SERVICE BULLETIN

NO. SB-AG-68

FWD FIREWALL MODIFICATION

MODEL
S2R-H80

Figure 68-2

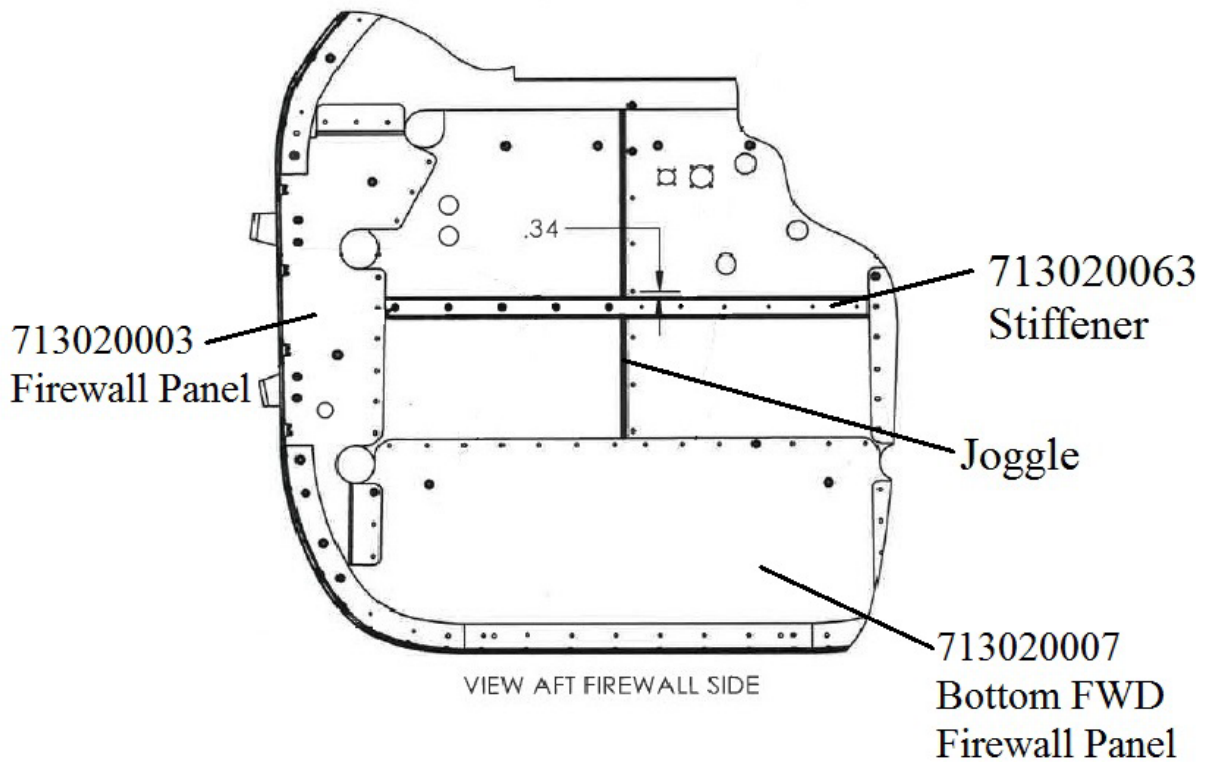
- Align Stiffener 713020063 to AFT firewall surface .34 inches below the 4th bolt from the bottom in the joggle. Ensure stiffener is parallel to the edge of the bottom FWD firewall panel 713020007. Stiffener should be equal distance between the left firewall panel 713020004 and right firewall panel 713020003. Shown in Figure 68-2.

Figure 68-3

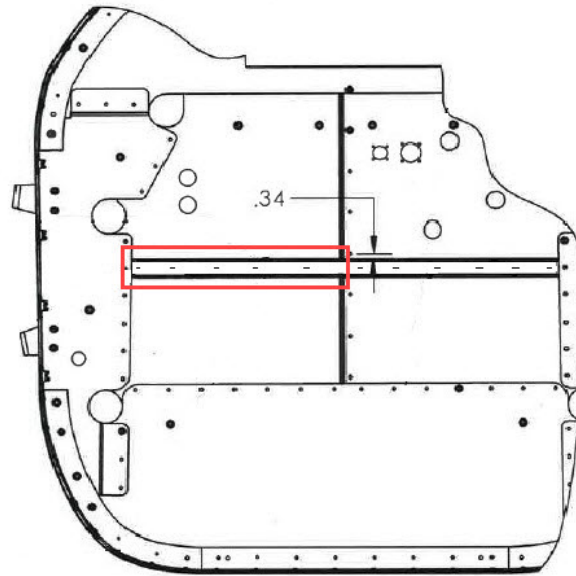
- Match drill (5) #19 holes through Left Middle FWD Firewall Panel 71302006 and Stiffener 713020063. See Figure 68-3.

Figure 68-4

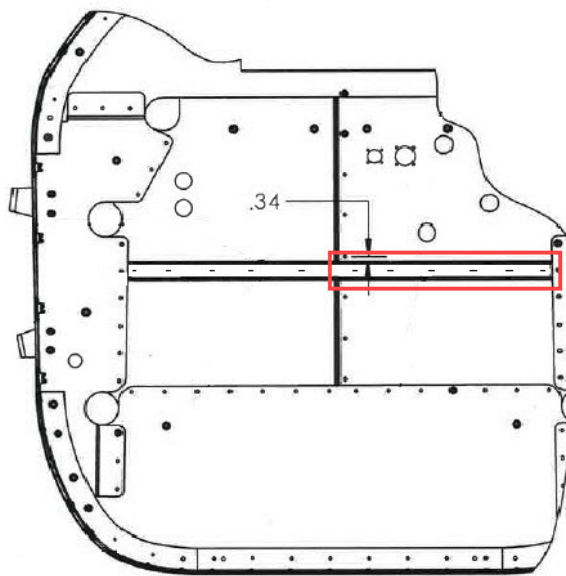
- Match drill (6) #30 holes through Right Inboard Firewall Panel 713020005 and Stiffener 713020063. See Figure 68-4.

Figure 68-5

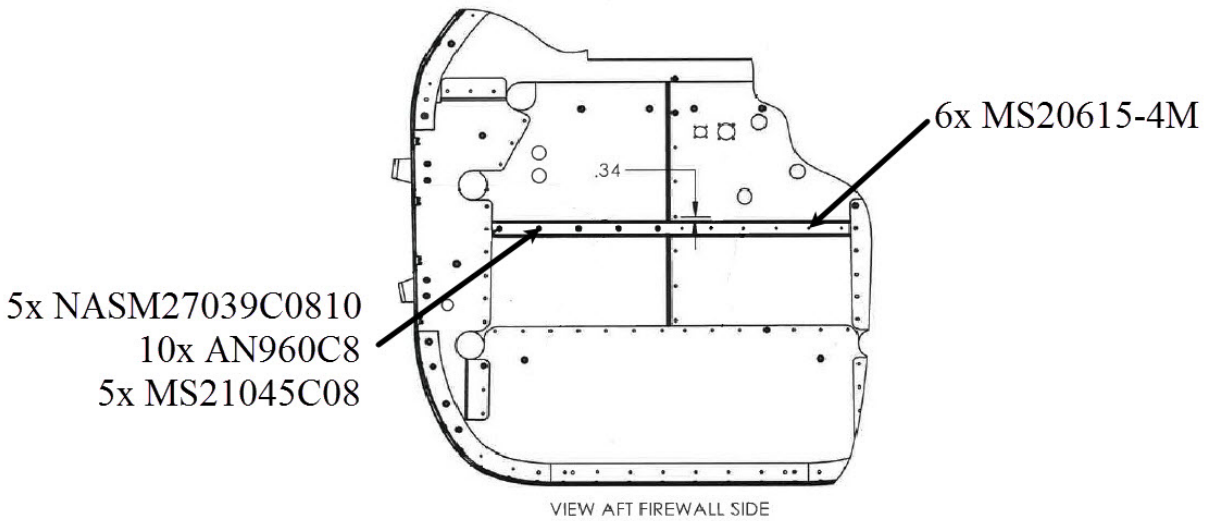
- Install stiffener on AFT surface of firewall panel using hardware shown in Figure 68-5.
